Appl. No. 10/660,084  
Amdt. dated November 17, 2004  
Reply to Office action dated August 17, 2004

### **REMARKS AND ARGUMENTS**

FIG. 1 (PRIOR ART)

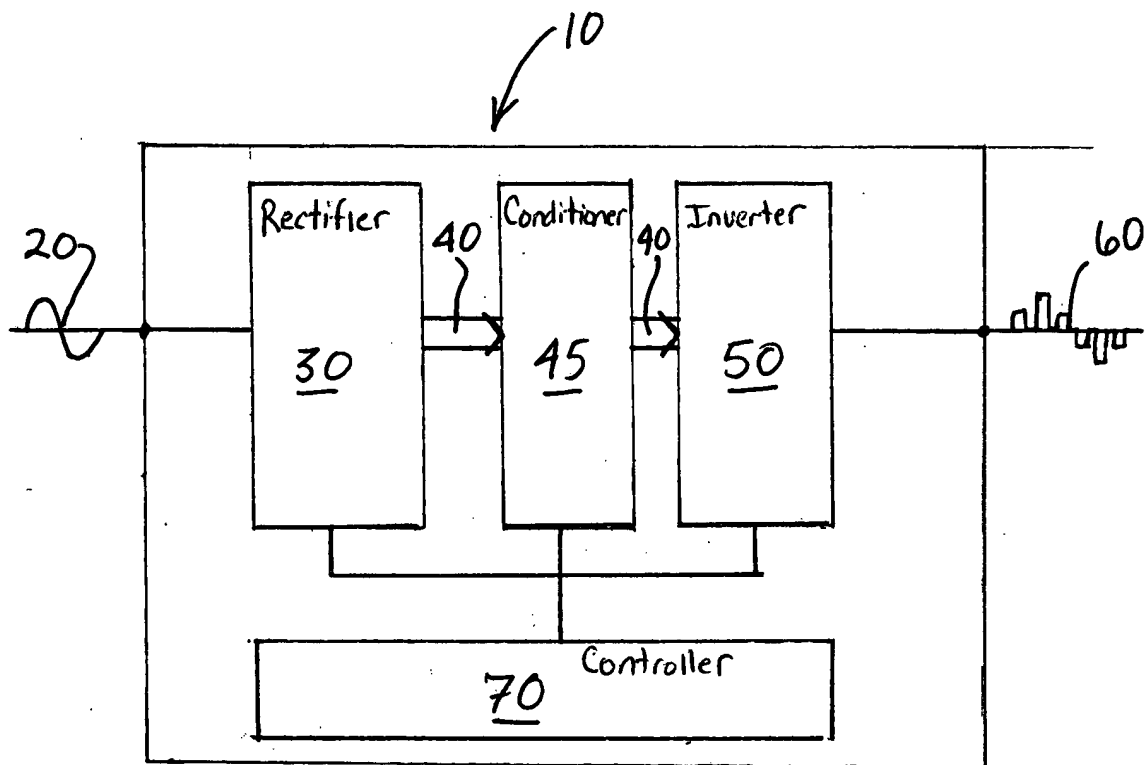
*(a) The boxes need to be labeled. For example, in Fig. 1, the box referenced, as 30 should be labeled "Rectifier" the box referenced, as 45 should be labeled "Filter", and so on for the remainder of the boxes and figures.*

*(c) Figure 1 should be designated by a legend such as —Prior Art— because only that which is old is illustrated. See MPEP § 608.02(g).*

Applicant has amended Figures 1, 2 and 3 by labeling each box with its appropriate name in accordance with Rule 83(a). No new matter has been added.

Applicant has amended Figure 1 by adding a "Prior Art" legend.

The attached sheets of drawings include changes to Figs. 1, 2 and 3. Figure 1 has been amended by adding a "Prior Art" legend and by labeling boxes 30, 45, 50 and 70. Figure 2 has been amended by labeling boxes 110, 120, 140 and 150. Figure 3 has been amended by labeling boxes 230, 240, 280, 290, 310, 320, 340 and 400.

FIG. 3

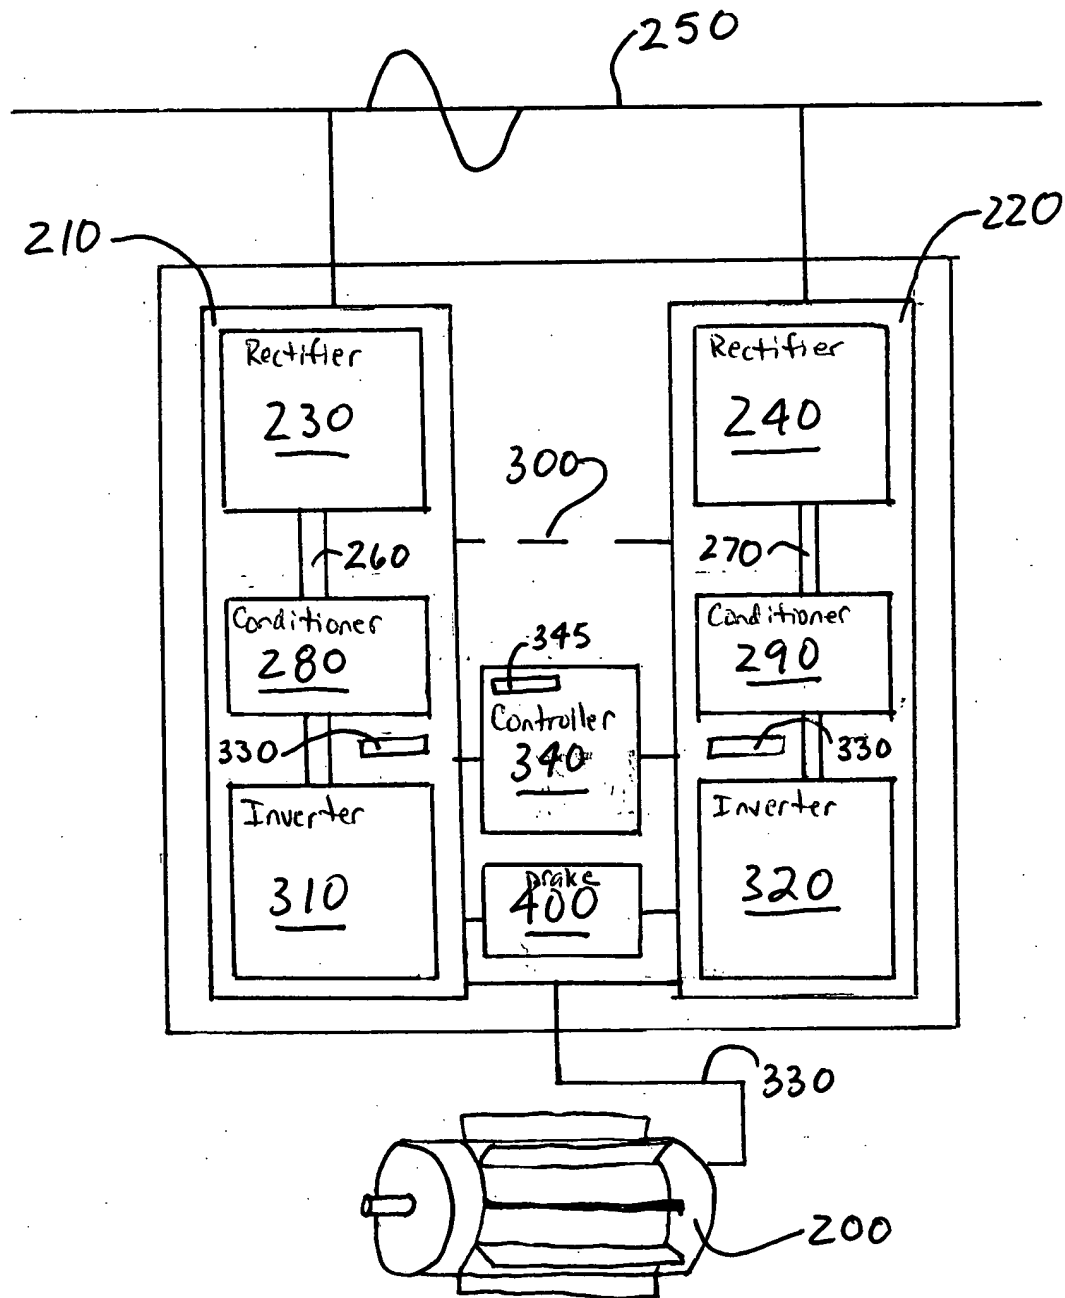
*(b) The drawings are objected to as failing to comply with 37 CFR 1.84(p)(4) because reference character "115" has been used to designate both a DC bus and a rectifier interface.*

Applicant has amended Figure 3 by changing the reference numeral 115 for the rectifier interface to reference numeral 117. The specification has been conformed to this change as well (see paragraph [0013]). No new matter has been added.
